WEST SUSSEX COUNTY COUNCIL CONSULTATION

TO:	Horsham District Council FAO: Matthew Porter
FROM:	Stephen Gee WSCC – Highways Authority
DATE:	8 July 2025
LOCATION:	Land To The South of Broadbridge Way Broadbridge Heath West Sussex
SUBJECT:	DC/25/0894 Full Planning Application for the erection of 89no. residential dwellings comprising dwellings (54no.) and apartments (35no.), 36% affordable homes, creation of new vehicular access on to Sargent Way, provision of public open space, landscaping and drainage solutions.
DATE OF SITE VISIT:	Site known to officer
RECOMMENDATION:	More Information / Modification

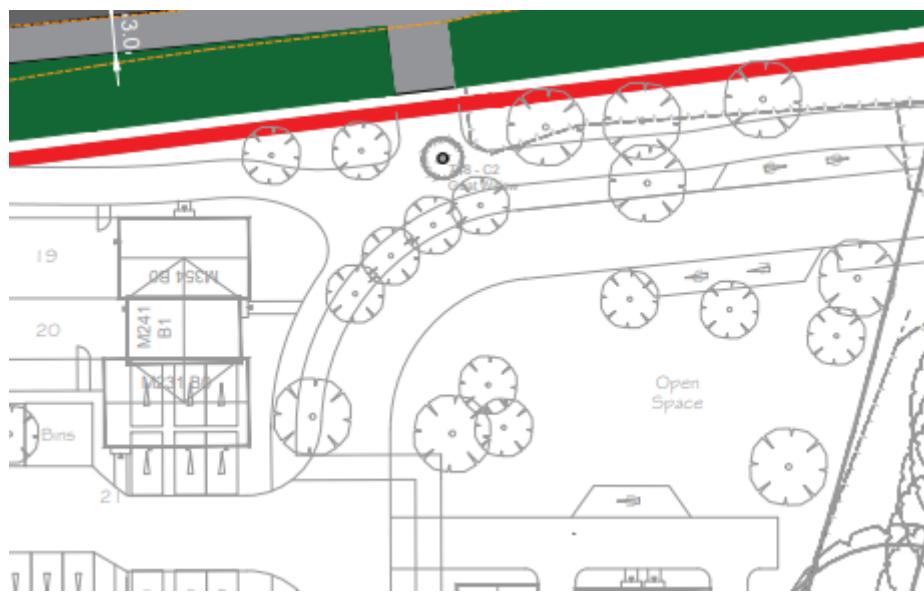
The plans show the provision of shared use link to the north connecting into a proposed crossing. There is a section of land that is not within the red line boundary shown below or within the highway boundary. The applicant should identify how connectivity will be provided.

- Land ownership issues to the North and the ability to construct a connection to the crossing
- Parking demand levels
- Modelling of Broadbridge Way/Wickhurst Lane and proposed mini roundabout.
- Links onto Carter Drive
